Title: Advisory Committee on Nuclear Waste  
133rd Meeting

Date: Wednesday, March 20, 2002

High-Level Waste Performance Assessment

Sensitivity Studies

## Barrier Component Sensitivity- 10k years (continued)

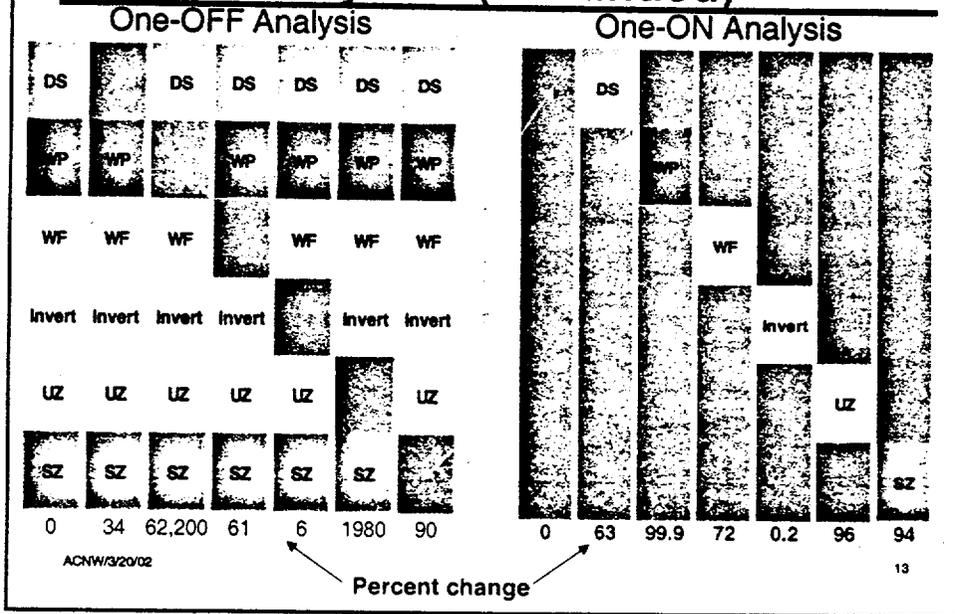
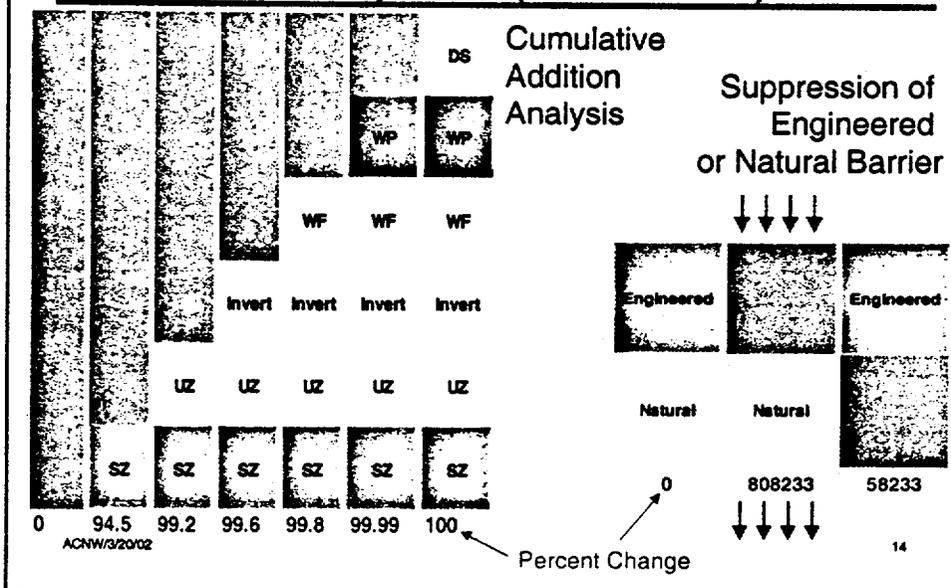
7 But on Slide 13, I'm having trouble  
8 relating this to the physical world in that on the  
9 one-OFF, if you remove the waste package, you have a  
10 62,200 percent change.

13 On the one-OFF analysis, when you remove  
14 the waste package, you have a 62,200 percent change,  
15 but with the one-ON analysis, none of the other  
16 barriers are there. You just add the waste package.  
17 You only have 100 percent change. Factor 2. It  
18 doesn't seem consistent with the physical world, as I  
19 visualize it.

18 I don't mean to be too severely because I  
19 know we are interested, like you are in barrier  
20 performance. But it strikes me, Dick just casually  
21 said it's a really difficult problem to figure out  
22 what it means to have a barrier suppressed. And I  
23 agree with that. It just doesn't make sense to me to  
24 even consider changes as if all the drip shields  
25 failed at Time Zero. I don't understand what you're

15 CHAIRMAN HORNBERGER: I have a question  
16 now that you have mentioned your one-ON analysis. If  
17 we look at that lefthand column, okay, you have a dose  
18 associated with that, is that right? What you said  
19 was that we could read those as 99.9 percent reduction  
20 in dose?

22 CHAIRMAN HORNBERGER: So my question is  
23 what is the dose in that lefthand column and how did  
24 you calculate it?

20 MR. MOHANTY: Let me explain the  
21 difference. Under the one-OFF analysis, the first  
22 column represents the nominal case. For the nominal  
23 case, the peak expected dose is .021 millirems per  
24 year, whereas under the one-ON analysis, we are  
25 determining the percent in change based on the first

1 column under one-ON analysis. And that number, I  
2 don't remember what that value is, but we are using  
3 that number to determine the change. So that means at  
4 most it can be that. So when we put the waste  
5 package, so 99.9 percent represents a reduction in  
6 what we observe under column 1.

24 MR. MOHANTY: Let me start with one-ON  
25 analysis. What that figure tells us is that on

6 So that tells us something. And also when  
7 we compare that say with an invert, we are seeing only  
8 2 percent change. Then we are going back to the total  
9 system for performance assessment code to determine  
10 why we are only getting .2 percent and we did go back  
11 and find that the way in what is modeled in what is  
12 supposed to reduce flow or delay transport, but it  
13 just so happens that the flow through invert is  
14 predominantly fracture flow.
